CHARLOTTE - MECKLENBURG Planning Commission

DATE:	June 18, 2008
то:	Gary Huss Zoning Coordinator	FROM:	Debra Campbell Planning Director

SUBJECT: Administrative Approval for Petition No. 2007-82 by Pope & Land Enterprises Attached are revised plans for the above petition. The plans have been revised to make minor changes to Le layout of the future roadways and to allow additional private streets. Since these changes are minor and does not alter the intent of the development and meet the requirements of the Charlotte Zoning Ordinance Section 6.207 Alterations to Approval, minor changes, I am administratively approving these plans. Please use these plans when evaluating requests for building permit and certificates of occupancy. Note all other ordinance requirements still apply.

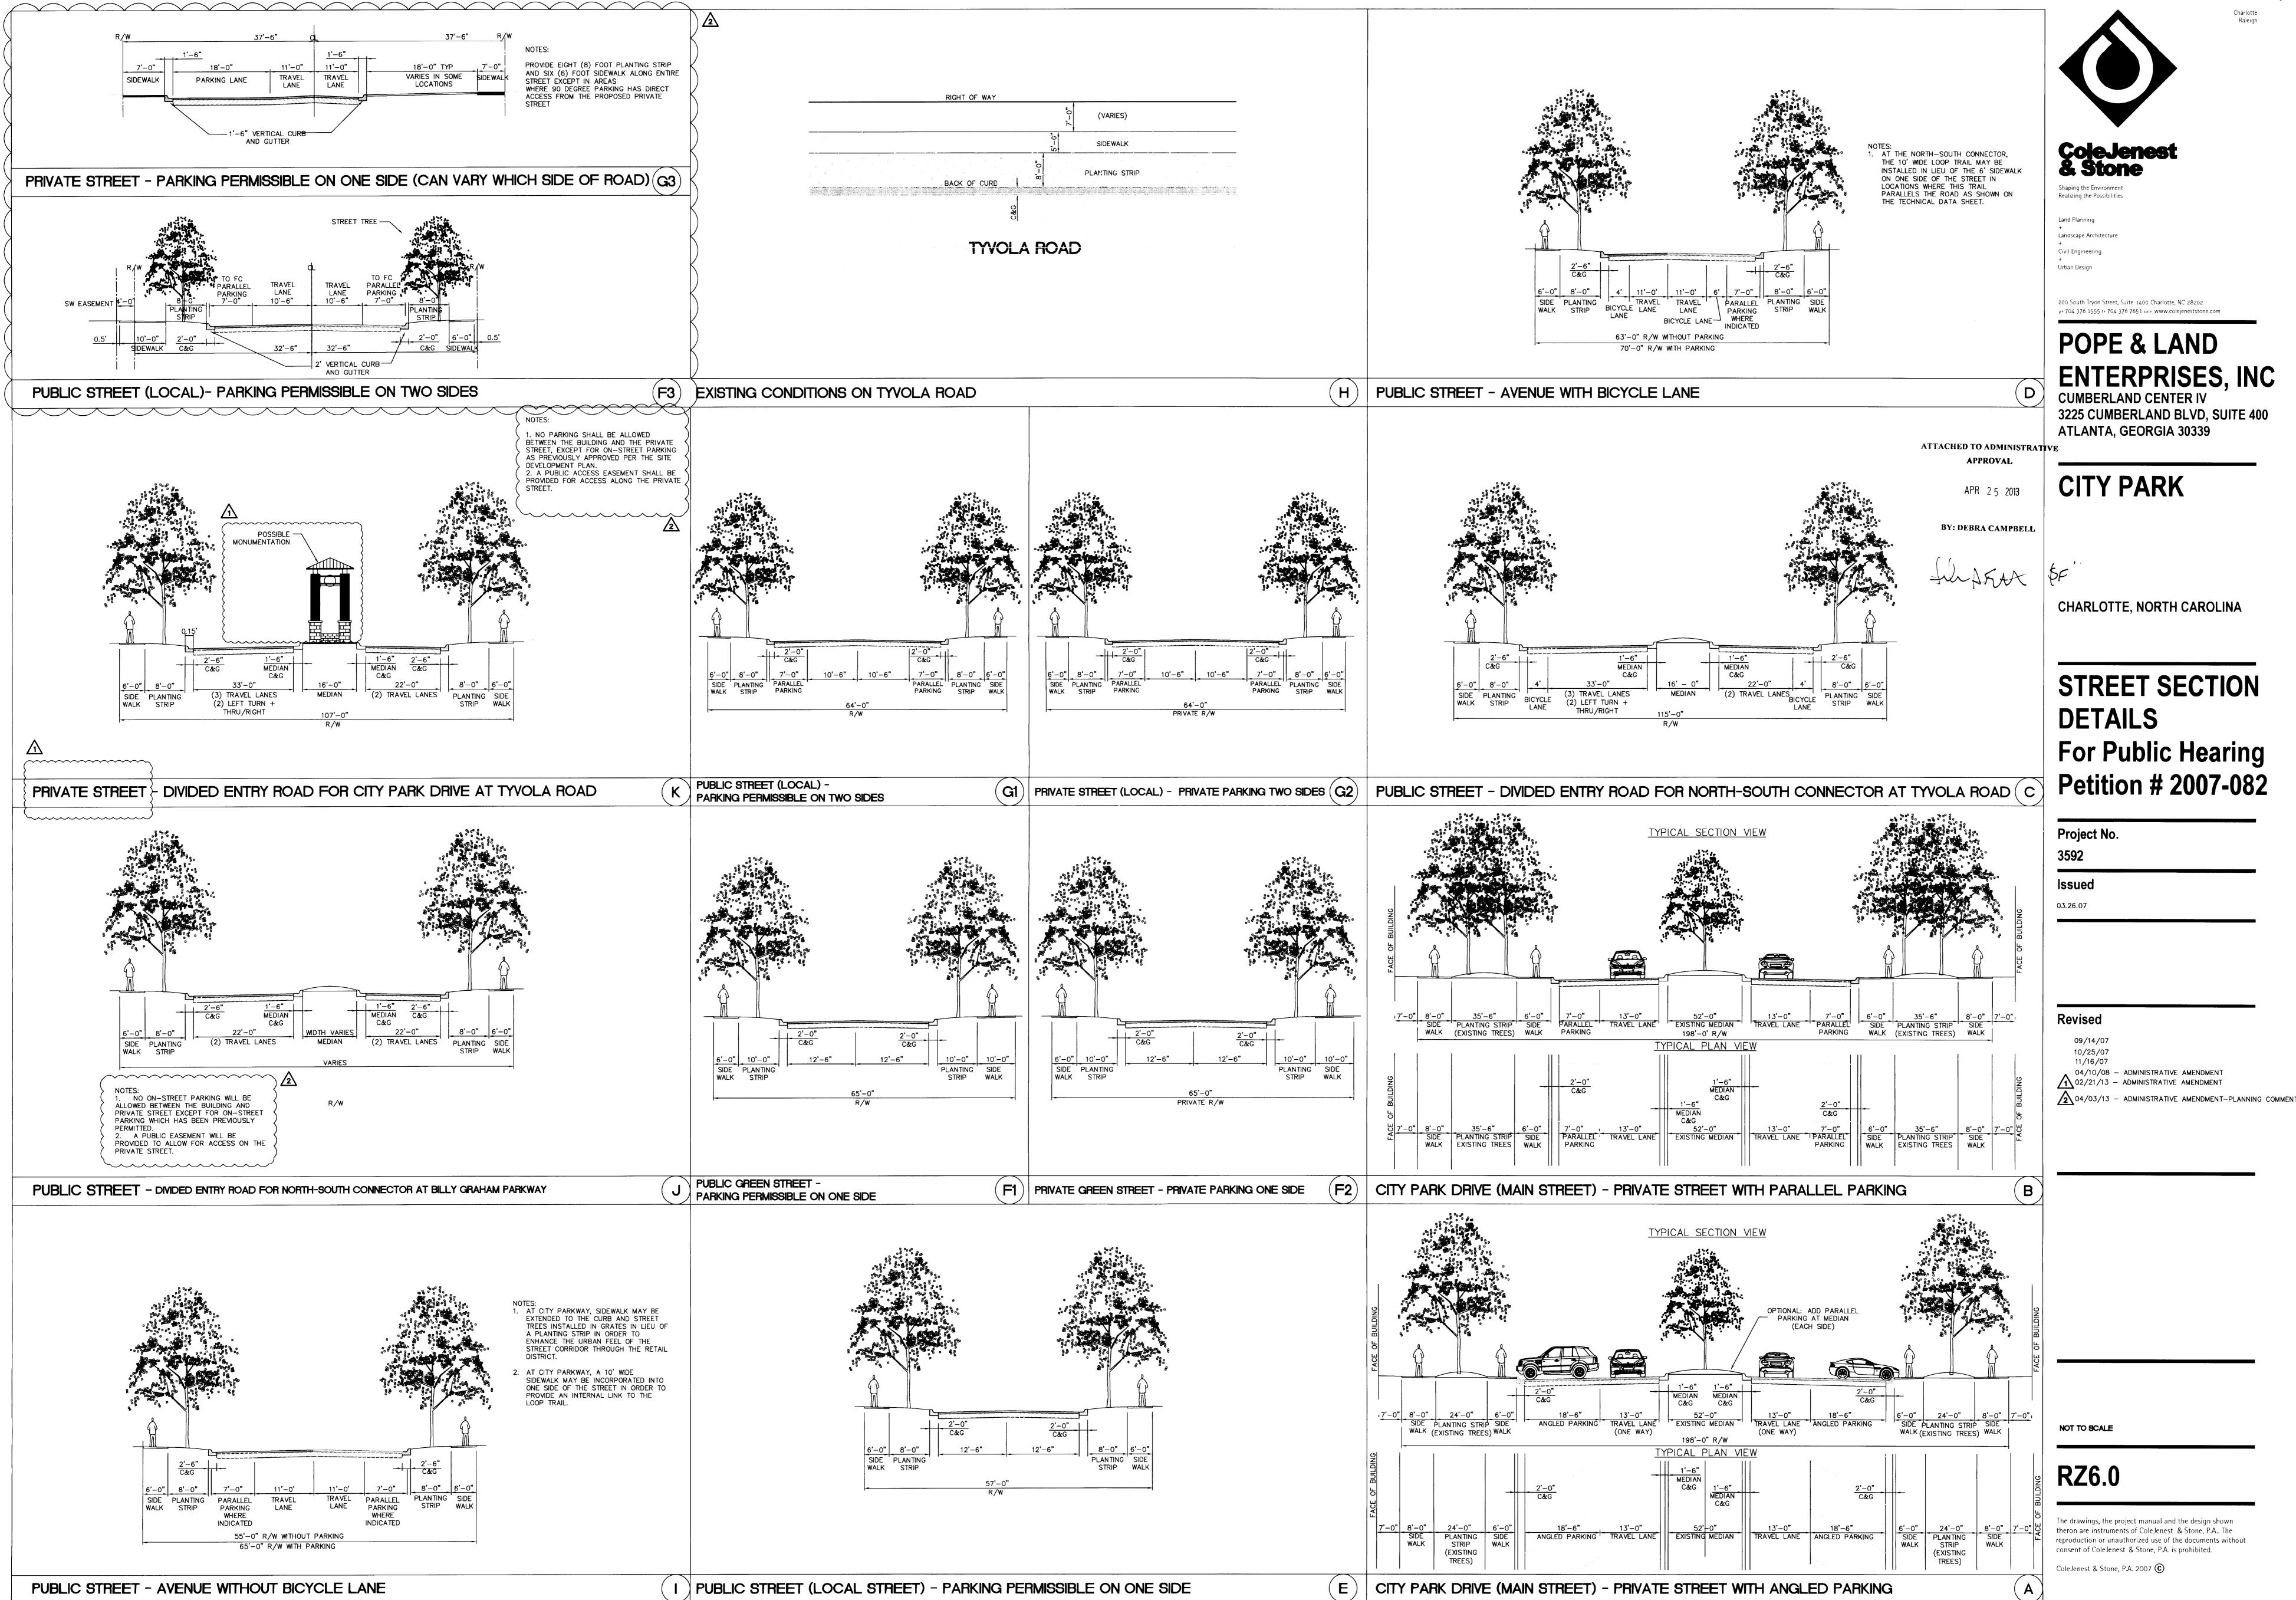
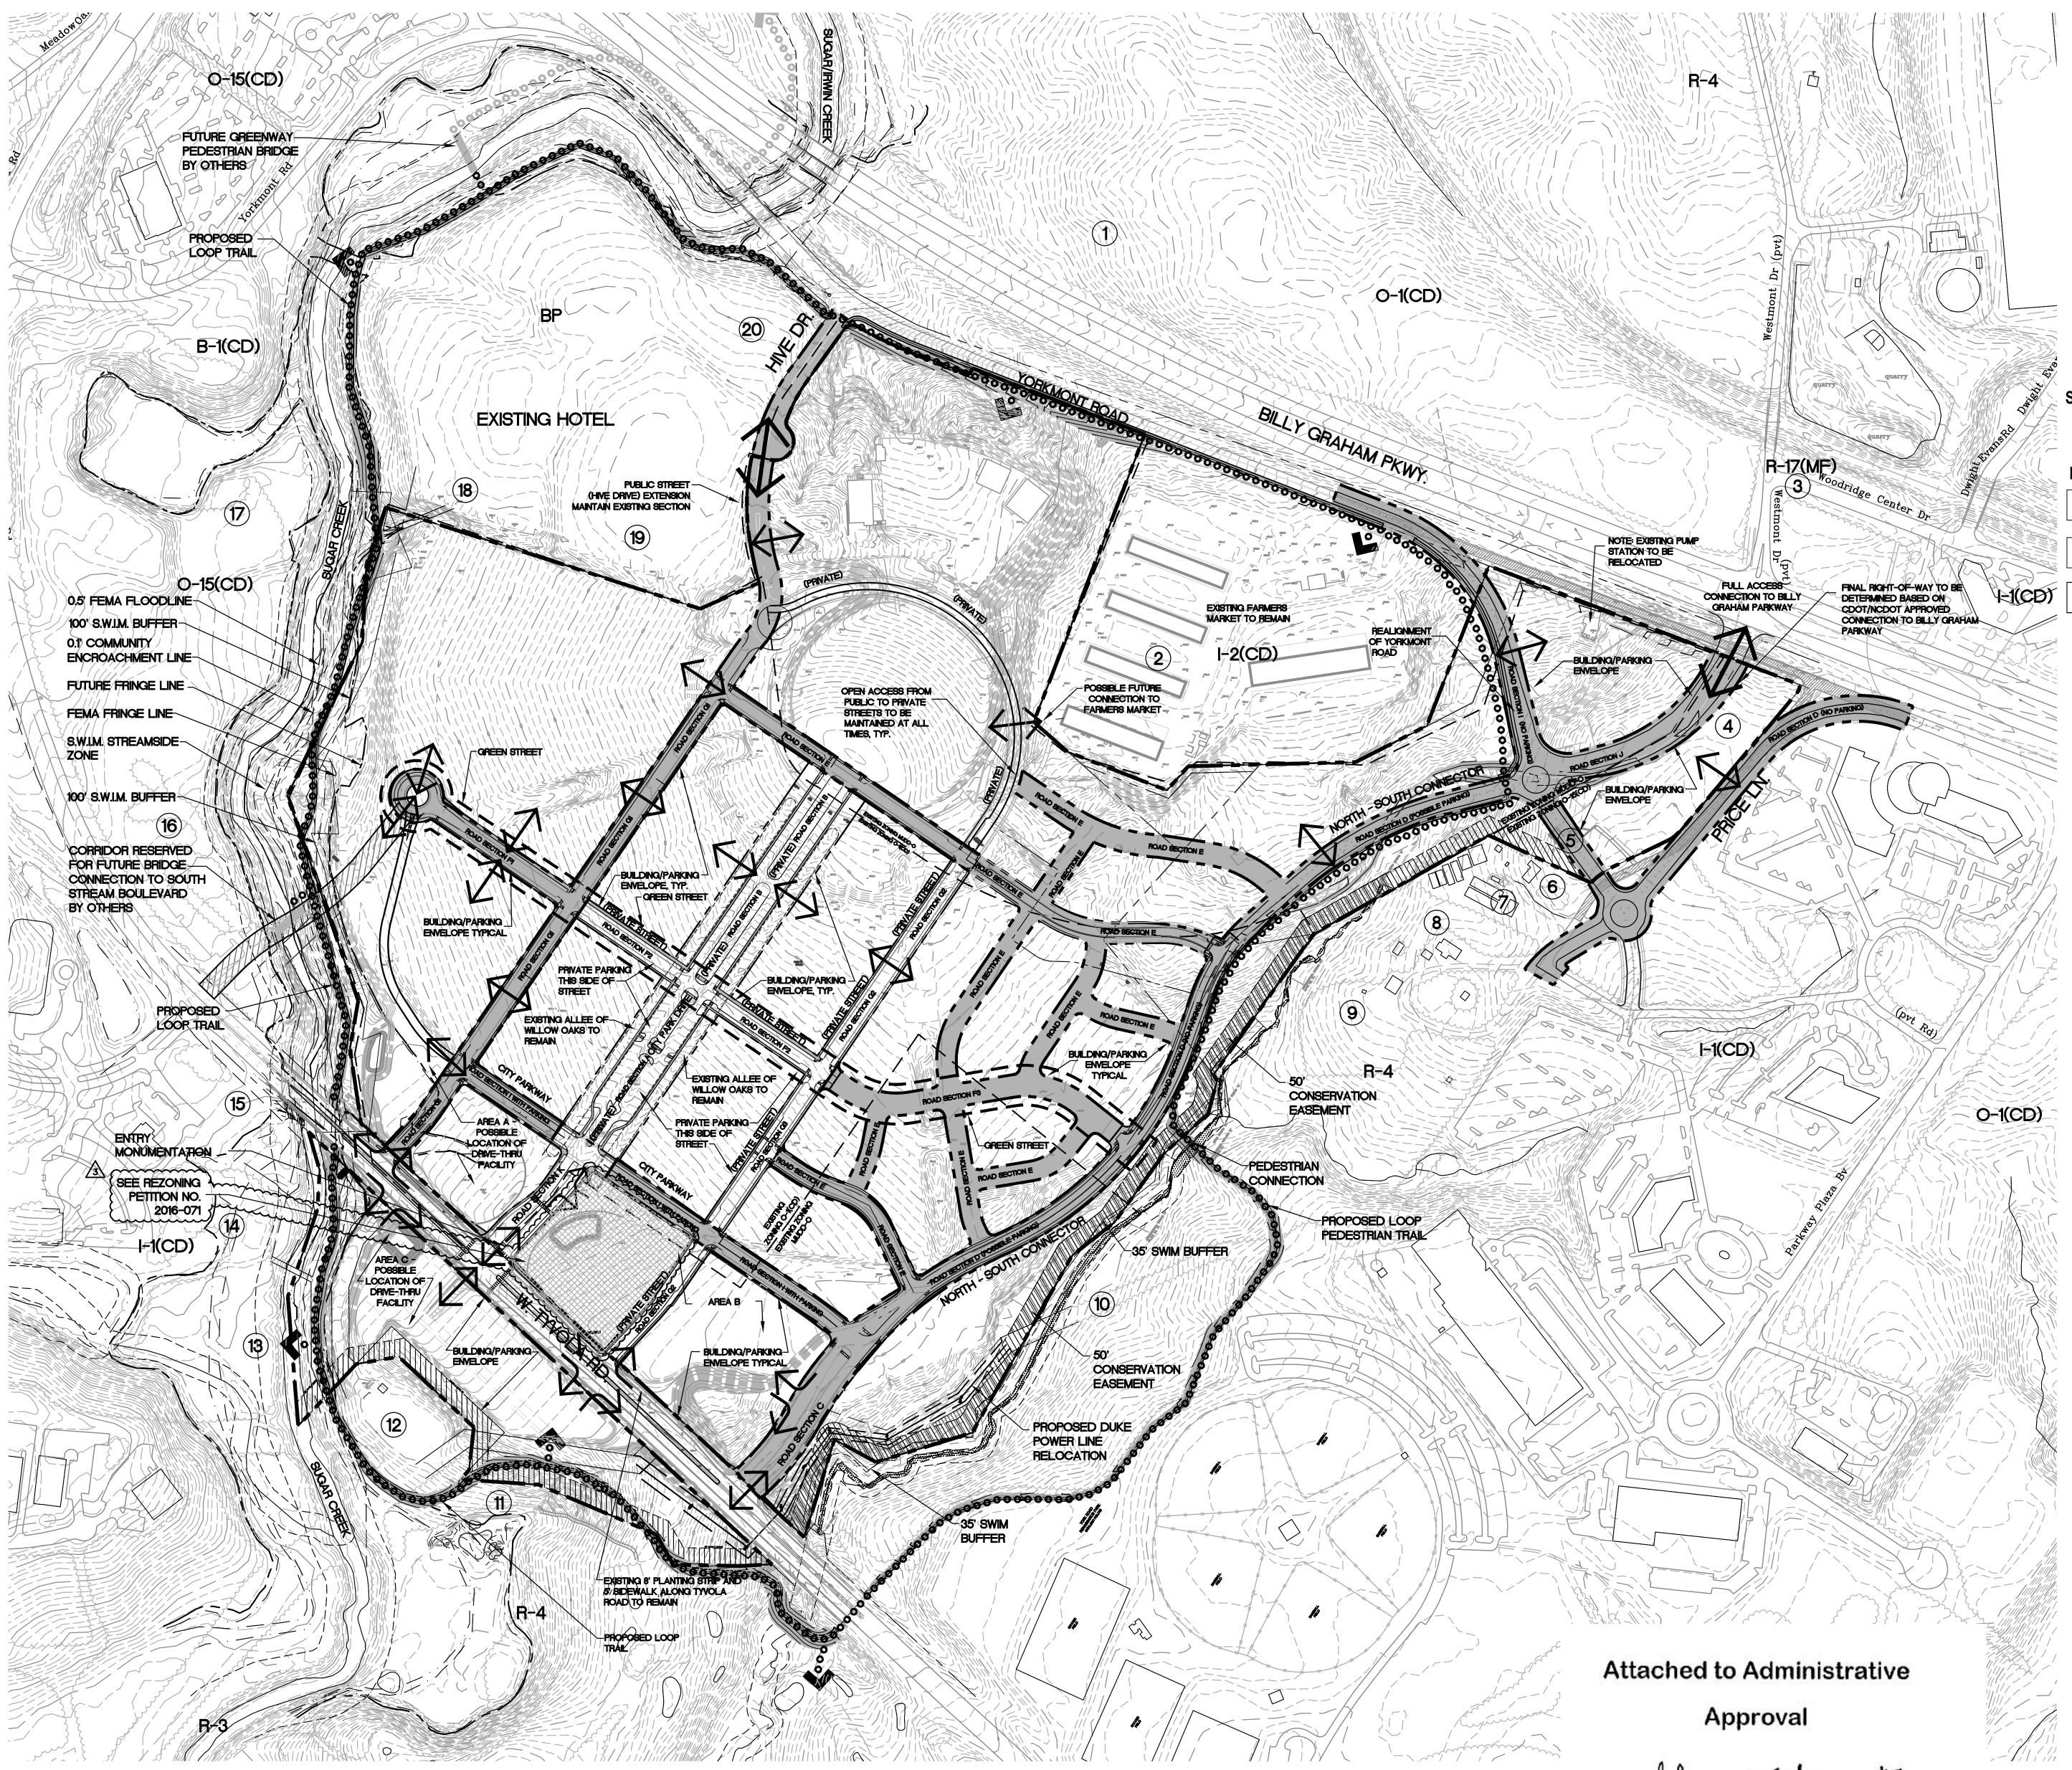
Reasons for Staff's support of the request:

• The site plan complies with the conditional notes and still meets the intent of the approved site plan by the City Council.

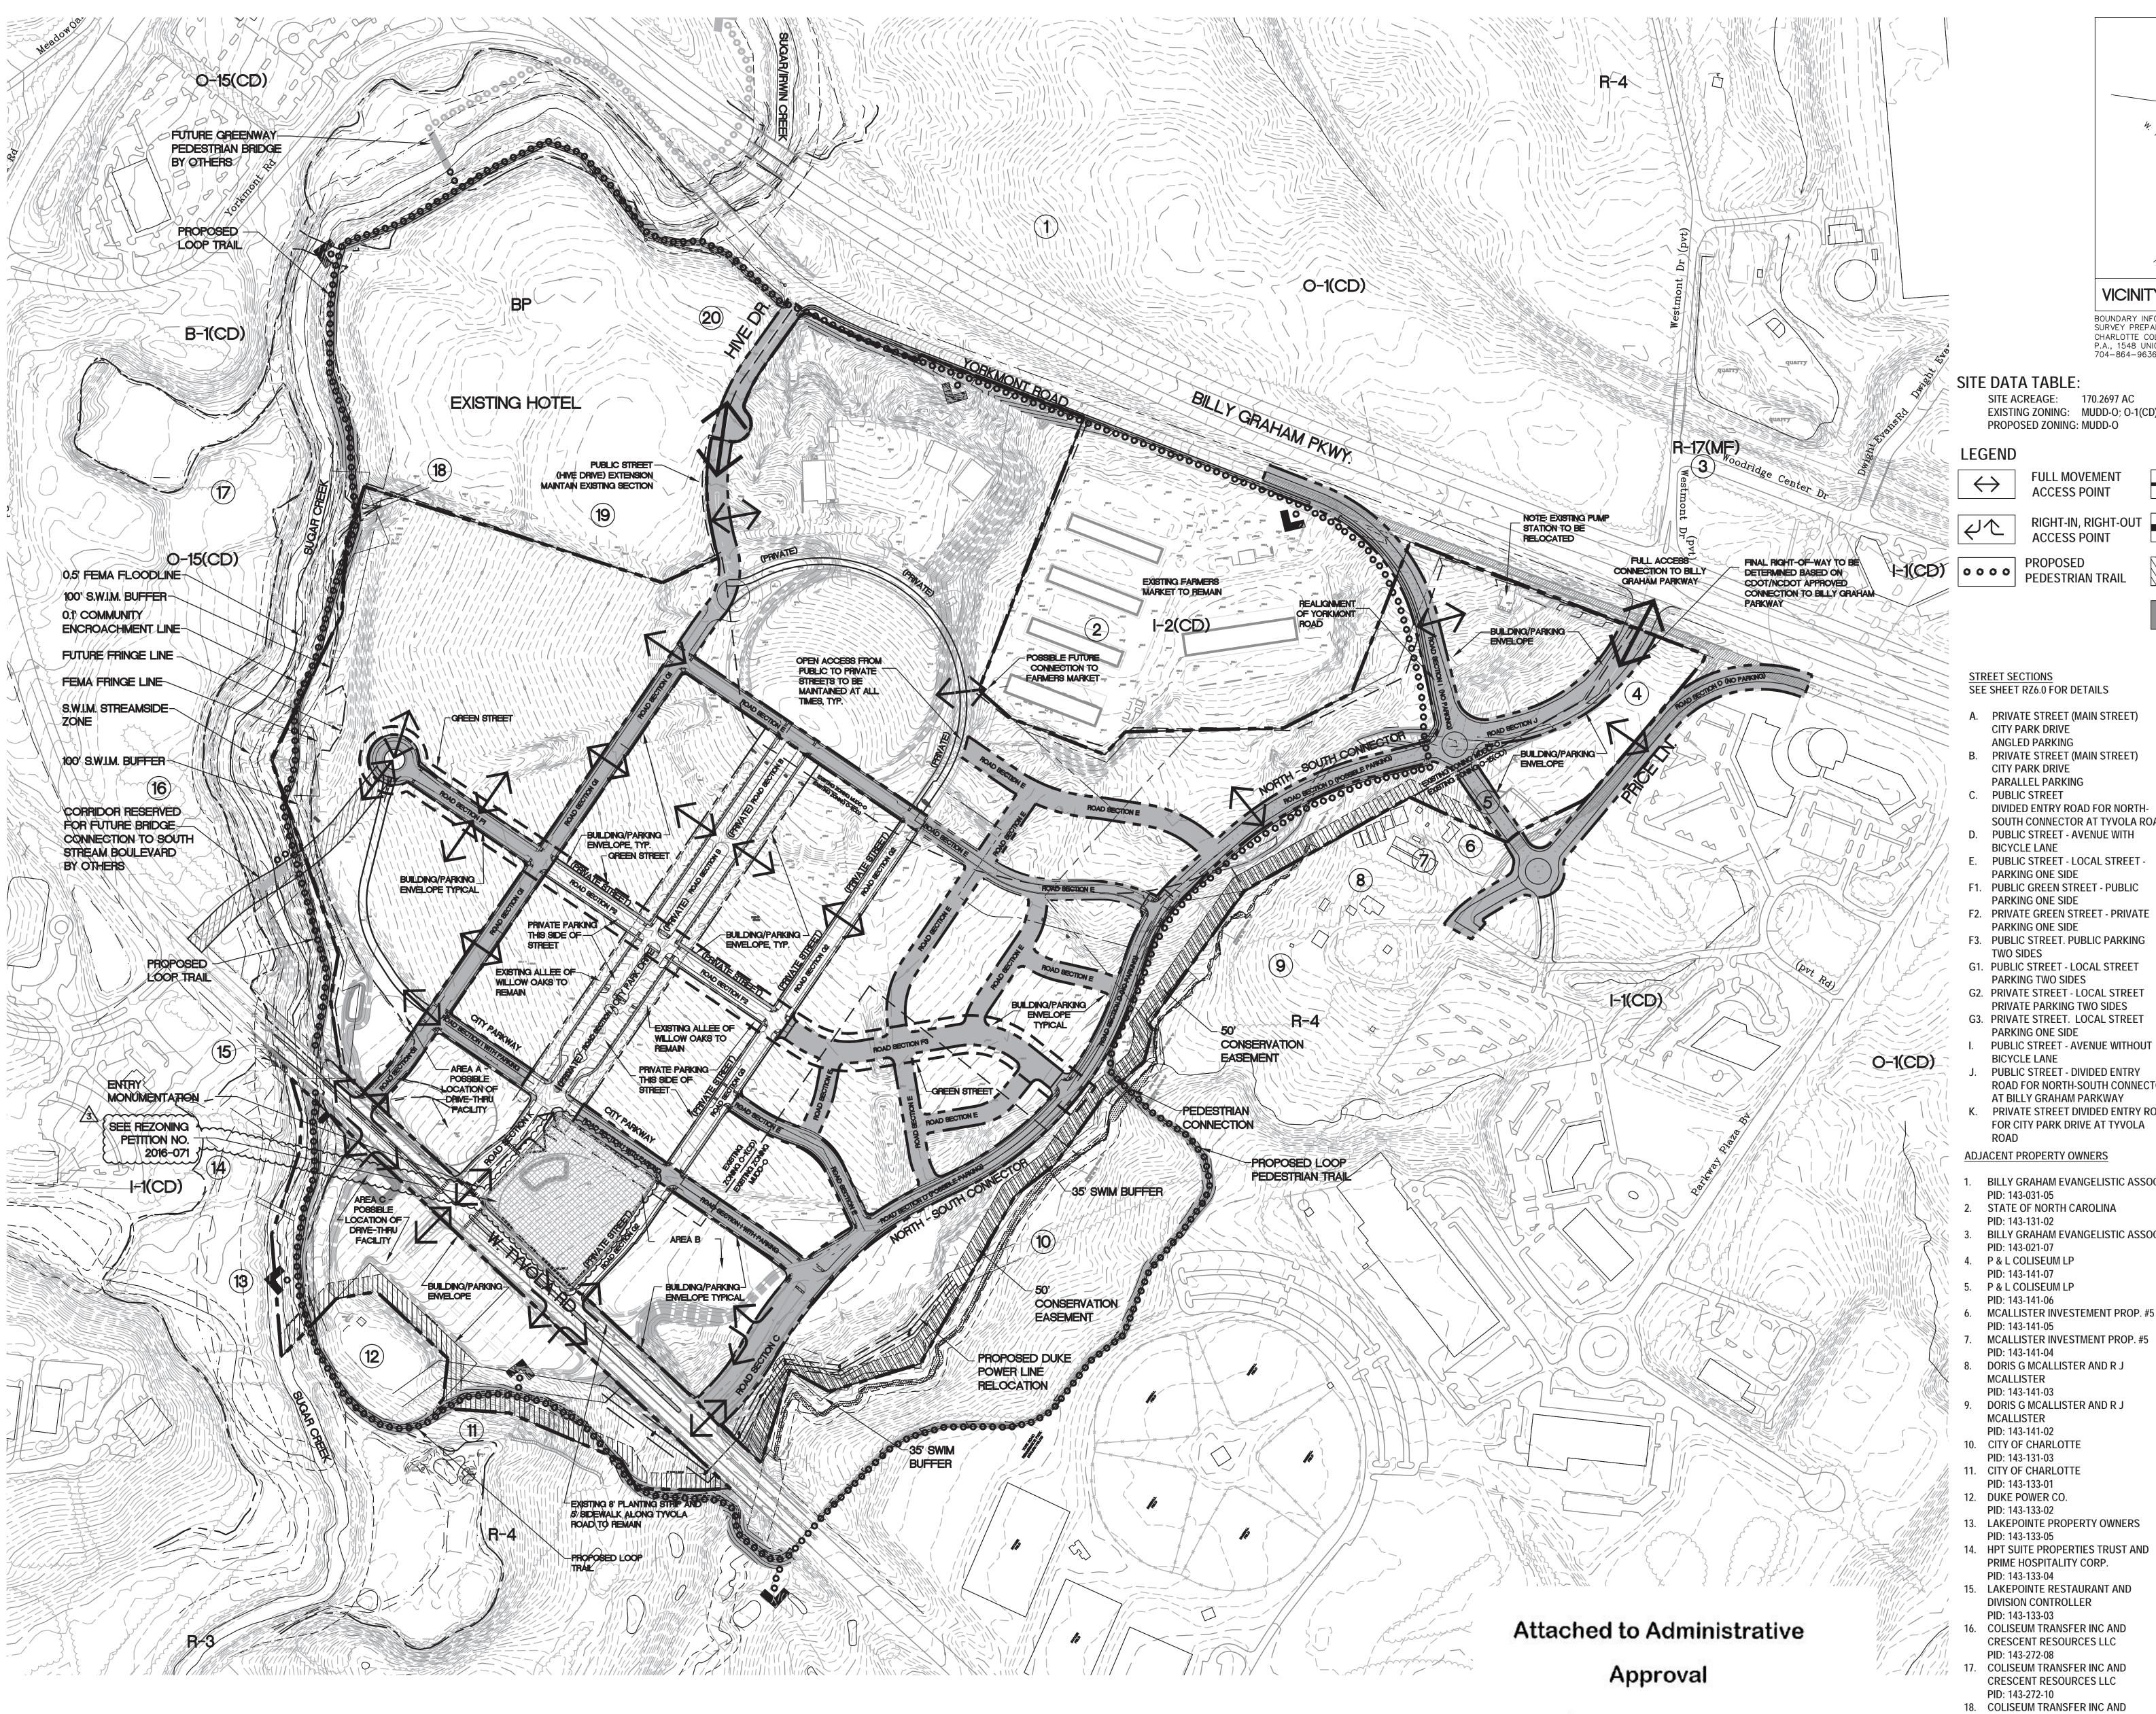
Attached is the revised site plan for the petition above. This request allows the modification of the proposed site plan as listed below. Since these changes do not alter the intent of the development and meets the requirements of the Charlotte Zoning Ordinance Section 6.207 <u>Alterations to Approval</u>, minor changes, I am administratively approving this plan. Please use these plans when evaluating requests for building permits and certificates of occupancy.

- Update of the existing development and numbers.
- Update due to the approval of petition 2017-205.
